ADDENDUM NO. 2 – April 21, 2025

RE: **CAESAR RODNEY SCHOOL DISTRICT – MAGNOLIA MIDDLE SCHOOL – HVAC RENOVATIONS (CONTRACT NO. SRS2503)**

This Addendum consists of five (5) pages, the attached revised Drawing A201 – Wall Sections and Elevations, and the attached revised Drawing M402 – Automatic Temperature Controls HVAC.

C1 SOUTH ELEVATION
SCALE: 1/4" = 1'-0"

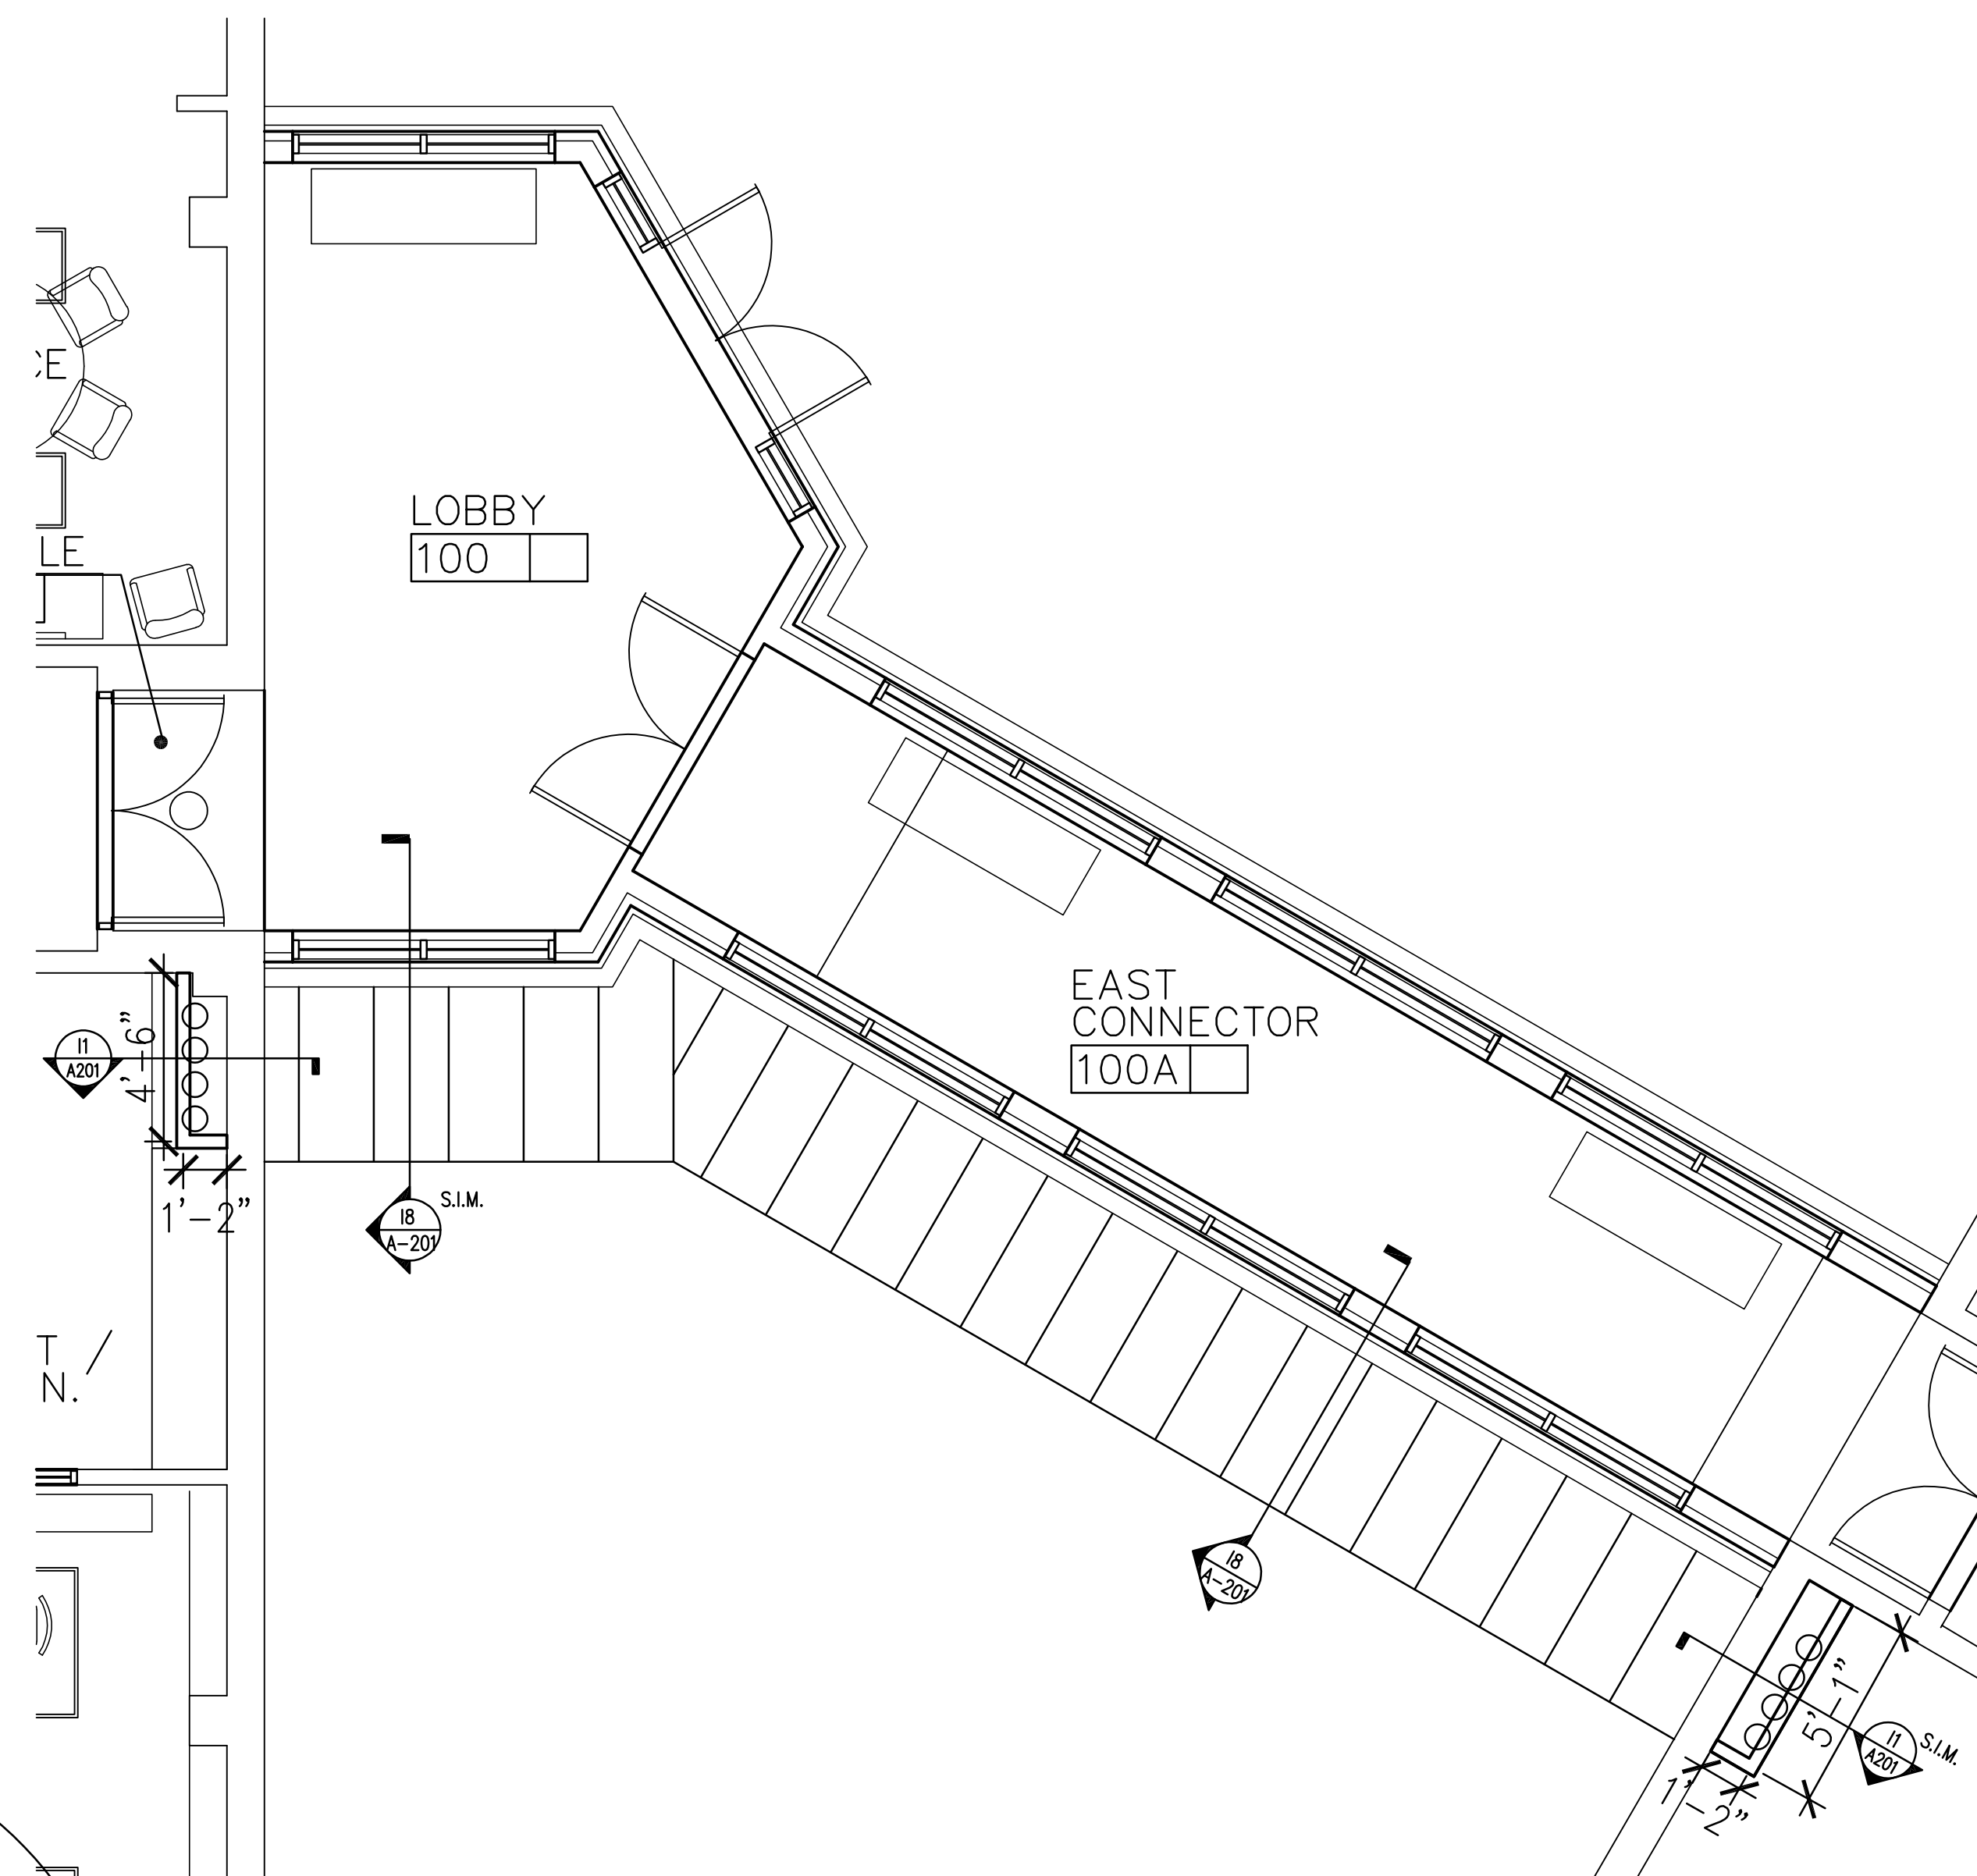
1. Question: Drawing A201 detail C1 where new EIFS is required what type of wall structure is behind the EIFS?
Response: Existing building is a pre-engineered building. Exterior wall in area of question is EIFS over exterior sheathing attached to girts.
2. Question: Drawing MD201 note 9 patch & repair asphalt can a detail be issued for repairs of the asphalt?
Response: Typical paving and paving tie-in details added to revised drawing A201.

15. Question: Drawing A201 detail C1 calls to enlarge opening which sends to detail G4/A20 which shows existing girts. This is not shown on the structural drawings. Please issue details on how to address enlarging the steel opening.

Response: Enlarged openings to occur between existing girts. Rough openings to be sized for louver. Provide 6" 16 ga galv steel studs to frame rough openings. Secure to existing girts. No girts should be cut or modified.
